SIL 30-1K2K-19
November 06, 2019
Page 1 of 1

SUBJECT: 1000, 2000 Series Models Transmissions Universal Transfer Case Adapter Rear Cover

MODELS AFFECTED: All 1000, 2000 Series Models Equipped Universal Transfer Case Adapter Rear Cover

Figure 1. Universal Transfer Case Adapter Rear Cover

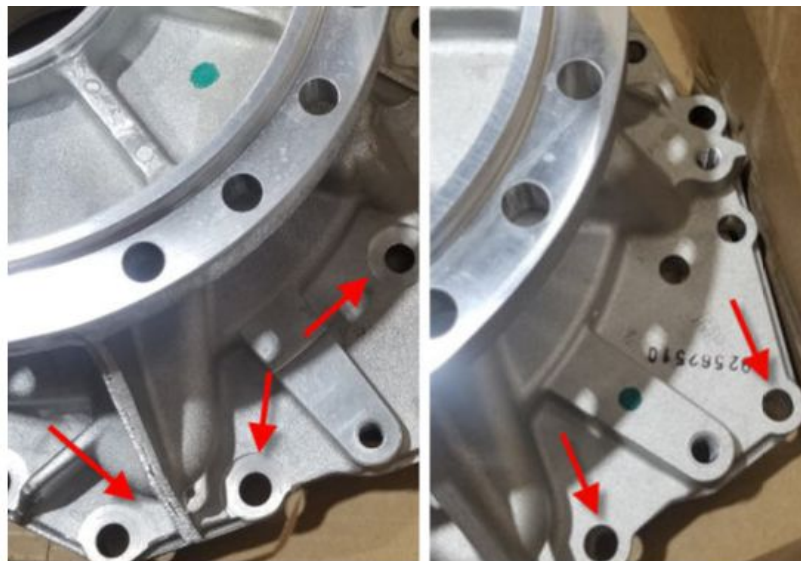
Universal Transfer Case Adapter Rear Cover P/N 29560343 has been superseded by P/N 29561803, refer to [Figure 1](#). The former rear cover P/N 29560343 was a permanent mold casting with spot faced bolt holes. The current rear cover P/N 29561803 is a die cast mold with no spot faced bolt holes. Forward and backward compatibility is unaffected.

The current P/N 29561803 is fully compatible with existing mating parts. Assembly torque is unchanged.
